STATE OF WASHINGTON
DEPARTMENT OF ECOLOGY

18-NWP-053

Re: Dangerous Waste Compliance Inspection on October 19, 2017 at Walker Tanker
HO-64-4294, RCRA Site ID: WA7890008967, NWP Compliance Index No 17.619

Washington Department of Ecology
Nuclear Waste Program
Compliance Report

Figure 1 – Diagram of Betts valve from *Estimate of Potential Heel in Tanker*

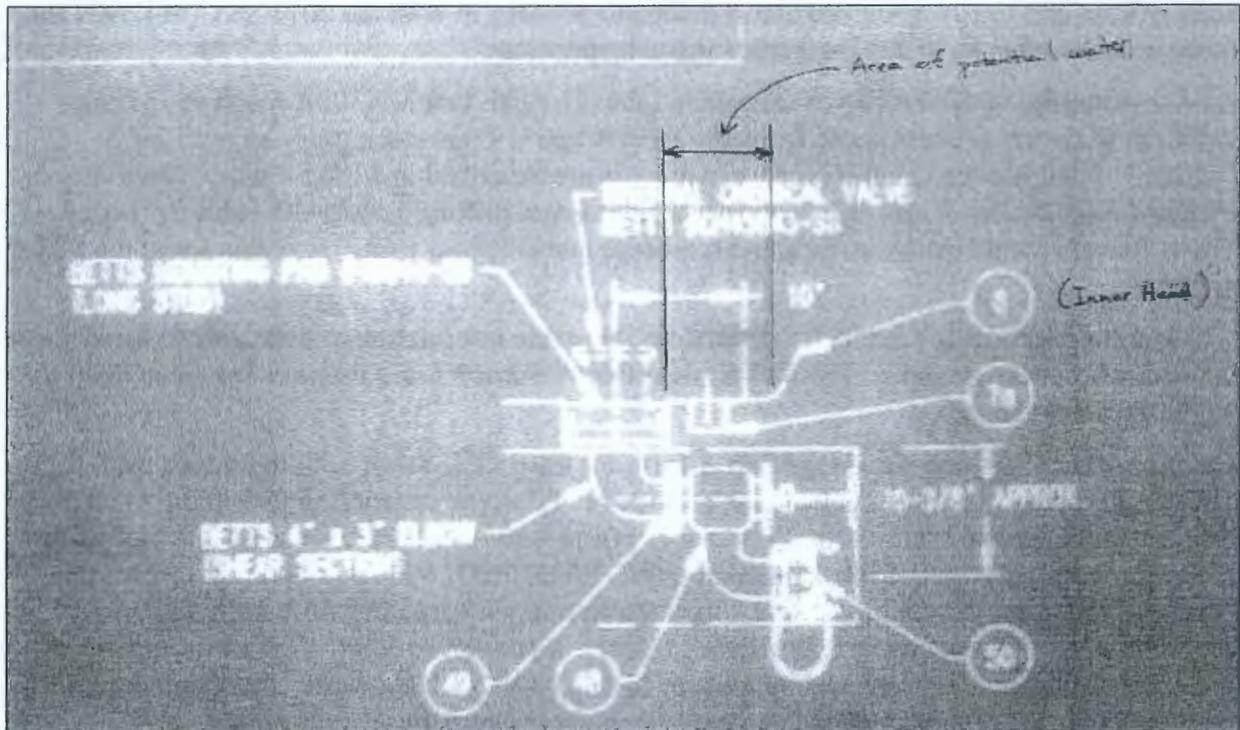
The first assumption is supported by a diagram (See Figure 1). I did not observe any supporting information for the second assumption. Figure 1 shows a recessed valve, but it also shows the top of the valve rising up several inches. I did not observe the one half inch estimate supported by any calculation or measurement.

To calculate the residual volume, it appeared that WRPS used a strapping chart to translate a one half inch liquid level into a tanker volume of 7 gallons. The only calculation performed was:

I observed nothing to support the assumption that residual volume would equal one half inch. I observed the strapping chart indicated its values were “theoretical.”
